DEALER SERVICE BULLETIN

Number: DSB14-0014J Date: 1/9/15 Supersedes: DSB14-0014D

Title: Control Circuit Breaker Recall

Figure 1 - Transformer Date Code Information all units (except S/N xxxxVxxxx)

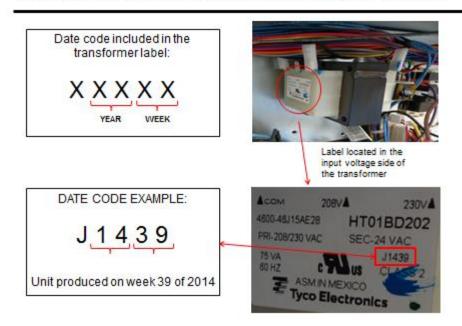
Bryant and Carrier have been informed by the manufacturer that some control circuit breaker(s) may fail to open if an over-current condition occurs. After further investigation and inspection, our supplier has adjusted the population of affected control circuit breakers and control transformers. Thus, the new population of affected units that incorporate a control transformer with integral circuit breaker is within the serial number range identified in Tables 2 and 3. Units that incorporate control circuit breaker(s) with a date code of 1423 (June 2, 2014) through 1445 (November 8, 2014) and the unit serial number is within the serial number range identified in Table 3 are affected. See for date code format in Figure 1, 2 and 4.

<u>Field Action:</u> Replace control transformer with integral circuit breaker if unit serial number is within the affected serial number range identified in Tables 2 and 3, and the control transformer has a date code within the following range:

Transformer Part Number	Transformer Date Code		
HT01BD202	J1435 to J1448		
HT01BD602	J1429 to J1448		
HT01BD702	J1439 to J1448		
HT01BD902	J1437 to J1448		
T111603026	H3414 or H3714

Figure 2 - Circuit Breaker Date Code Information

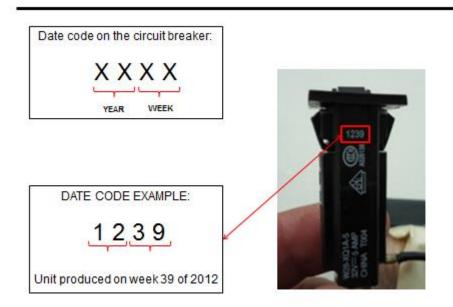
Replace control circuit breaker if date code is 1423 (June 2, 2014) through 1445 (November 8, 2014) and unit serial number is within the affected serial number range identified in Table 3. Complete the attached check sheet and return as indicated. All field reworked defective circuit breakers (individually or integral with control transformer) in installed equipment (those at a job site or customer location and not in inventory) should be rendered inoperable and disposed of in an EPA certified manner.

Control circuit breakers manufactured starting with date code prior to 1423 (June 2, 2014) or after 1445 (November 8, 2014) meet the component specifications. Units falling out side of this affected date range may be released from the previous quality hold and are cleared for shipment and sale.

Figure 3 - Rework Verification

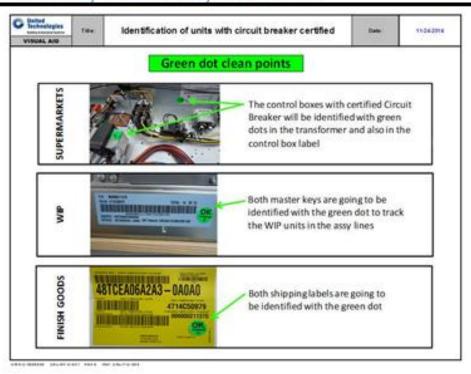
Table 2 and Table 3 are manufactured with properly functioning control circuit breakers and control transformer with integral circuit breaker. Units within the serial number range that have been reworked at the factory can be identified by a colored dot located as shown in Figure 3, 5 and 6.
